CERTIFICATE OF APPROPRIATENESS

Property: 417 West 12th Street, tract 19a, 20a, and 21a, block 183, Houston Heights Subdivision. The property includes a historic 1,007 square foot residence situated on a 4,100 square foot (41' x 100') interior lot.

Proposal: Alteration – *Resubmittal* The applicant applied for a COA to construct a two story 1,498 square foot addition on top of and to the rear of a one story 1,007 square foot Contributing residence on at the November 2014 HAHC meeting. The HAHC accepted staff's recommendation to deny the item for not meeting criteria 1, 4, 8, and 9. The applicant has proposed the following revisions:

EAST SIDE ELEVATION

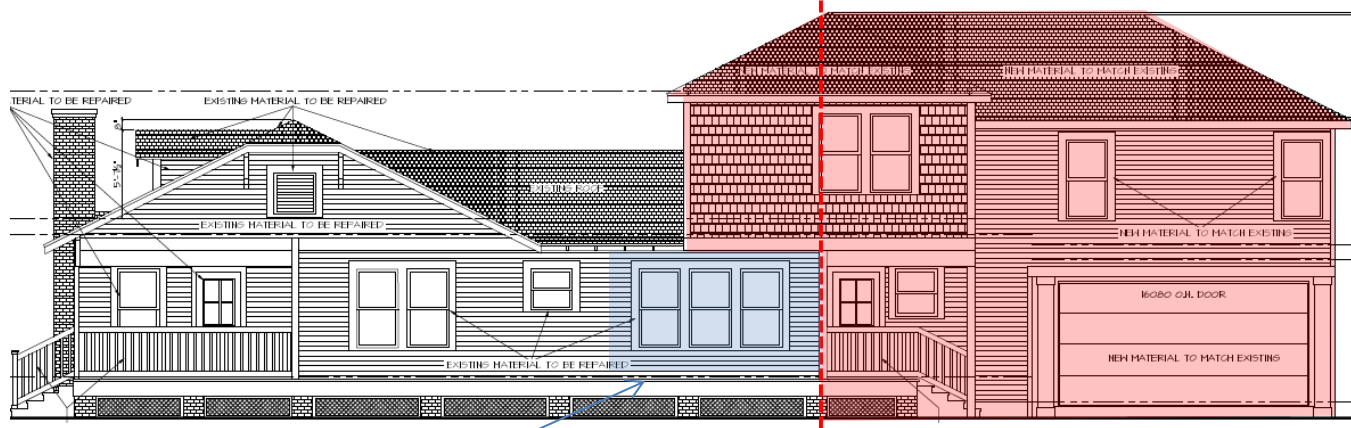
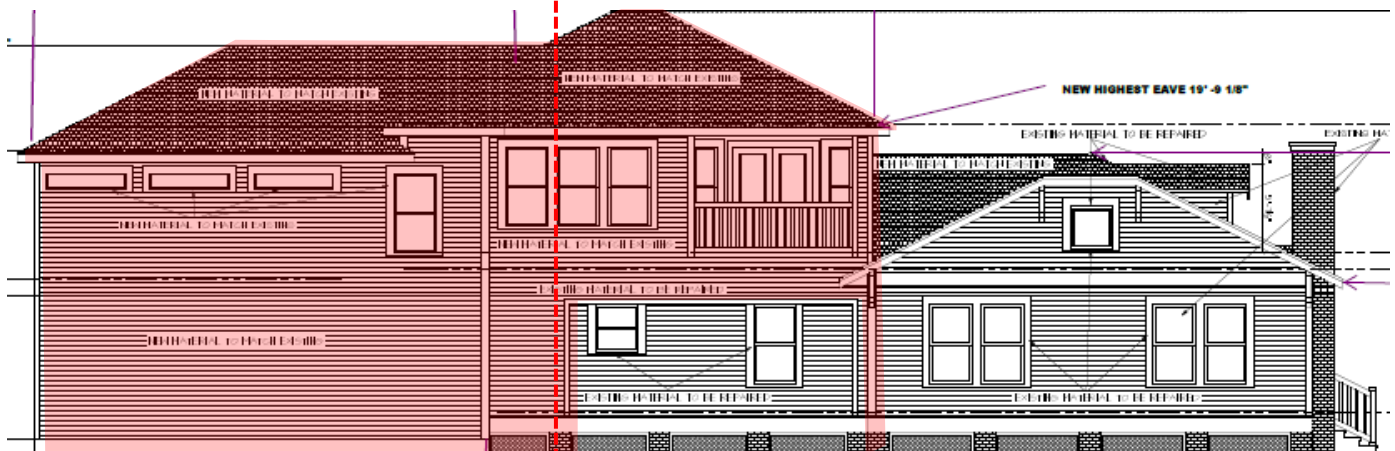
Red Dashed Line indicates the original rear wall of the existing house

Wall with three windows is particularly unlikely to support the added load of the second floor

WEST SIDE ELEVATION

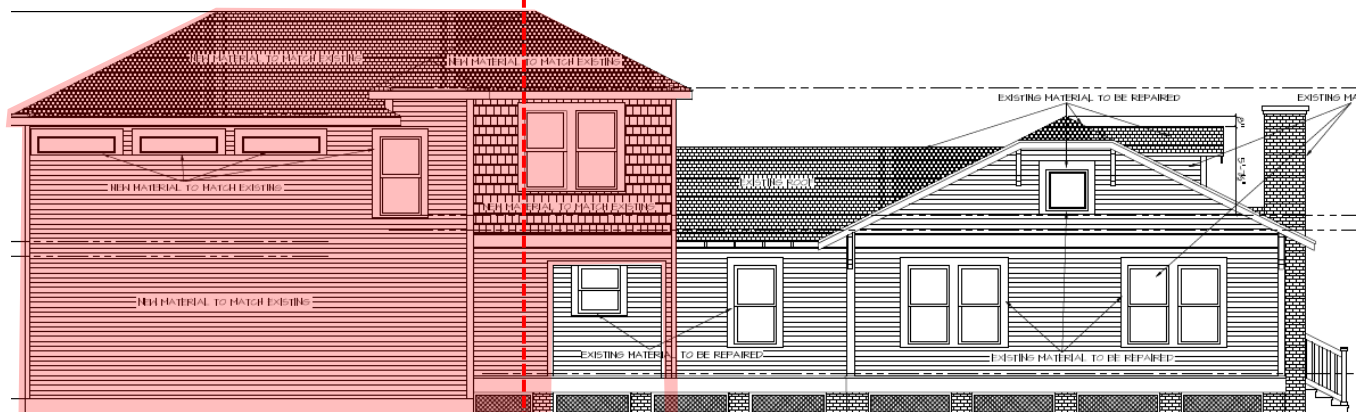
Red Dashed Line indicates the original
rear wall of the existing house

SITE PLAN

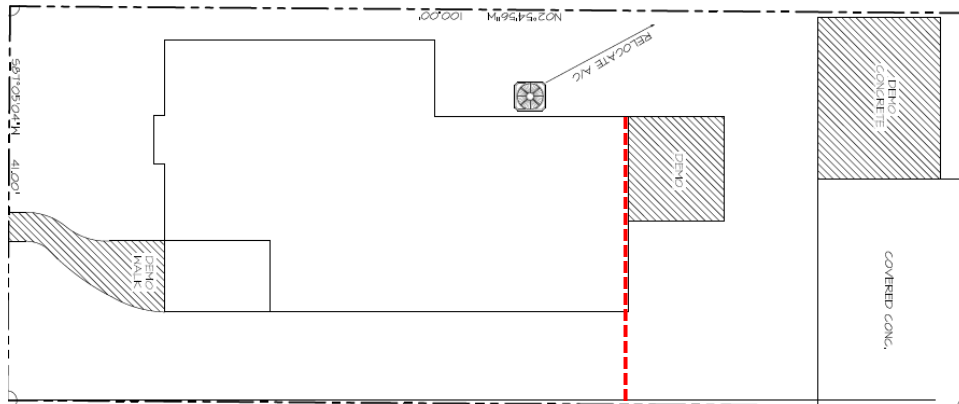
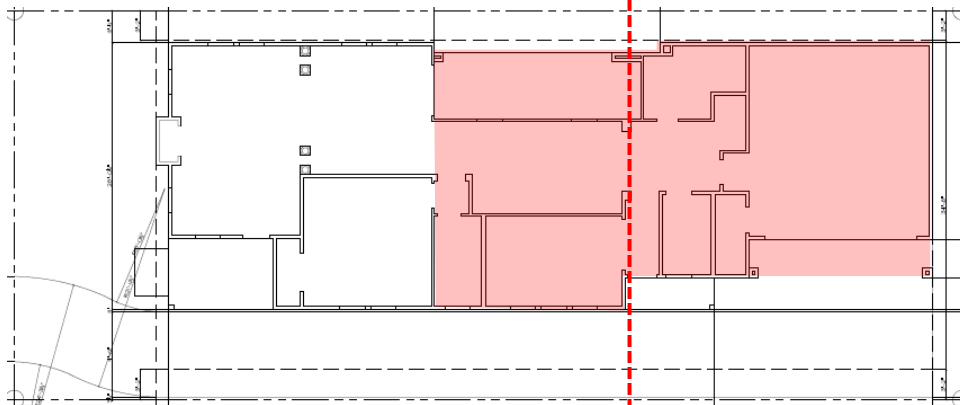
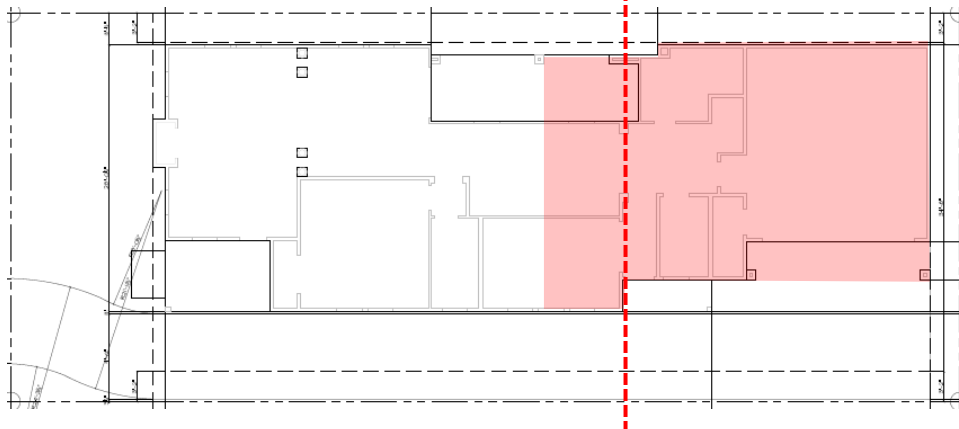
Red Dashed Line
indicates the
original rear wall
of the existing
house
